**Comments of the Natural Resources Defense Council (NRDC) on the 2012-2022
Preliminary Staff Electricity and Natural Gas Demand Forecast**

Docket Number 11-IEP-1C

September 15, 2011

Figure 1: Uncommitted Efficiency Reduction in Energy Growth¹⁶

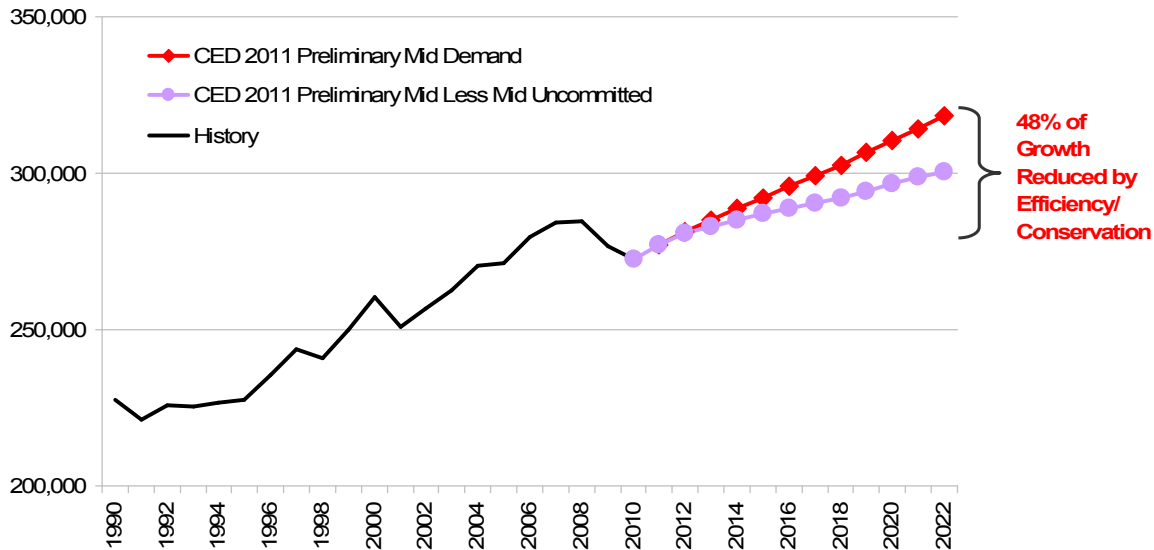
4. NRDC recommends that the CEC incorporate the incremental uncommitted energy efficiency into the statewide electricity consumption forecast, as doing so improves the accuracy of forecasted energy growth by 48%.

The Preliminary Forecast should include efficiency savings beyond 2012 in order to be accurate. However, the Preliminary Forecast (and all graphs besides those on pages 189-191) currently exclude all savings from efficiency programs coming online in 2013-2022—nearly the entirety of the forecast period.¹⁴ Energy efficiency will continue to provide savings and will continue to be California's top priority resource. Excluding the savings from future efficiency programs and policies not only goes counter to state policy, but it creates an inaccurate forecast because the savings from efficiency are reasonably likely to occur, which is the criterion for determining what should be included in the forecast. Excluding future efficiency savings causes the forecasted growth to be off by 48%. That is, energy growth from 2012-2022 is expected to be **about half** of what is presented in the statewide electricity consumption forecast, after accounting for future energy efficiency.¹⁵
